DOCKETED	
Docket Number:	19-BSTD-03
Project Title:	2022 Energy Code Pre-Rulemaking
TN #:	236761
Document Title:	Parker Boiler Co Comments - 2022 Energy Code Pre- rulemaking Title 24 Part 6
Description:	N/A
Filer:	System
Organization:	Parker Boiler Co
Submitter Role:	Public
Submission Date:	2/12/2021 2:36:55 PM
Docketed Date:	2/12/2021

## 2022 Energy Code Pre-rulemaking Title 24 Part 6

Case Report 2022 Title 24 Part 6 Final Case Report Codes & Standards Enhancement Initiative, California Statewide Utility Codes & Standards

Docket # 19-BSTD-03 2022 Energy Code Pre-rulemaking

## 3.) <u>Seismic</u> -Food / Drink Process

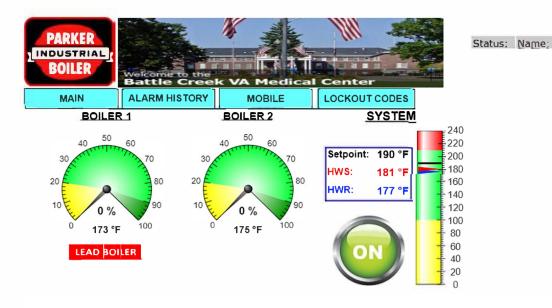
As you can see from 7-day & 24 hour views the boilers seem to be started daily on weekdays and the daily hourly use of the boiler likely depends on product demand.

## 4.) Spica - Process to Make Varnish

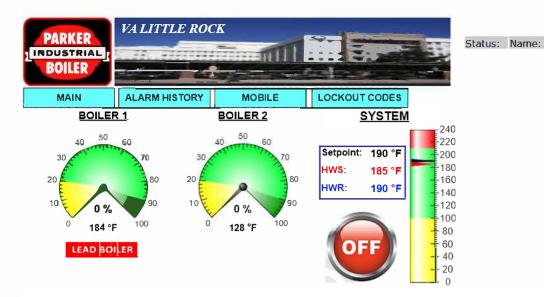
As you can see form the 7 day & 24 hour views the boiler is started perhaps 1-3 times per week.
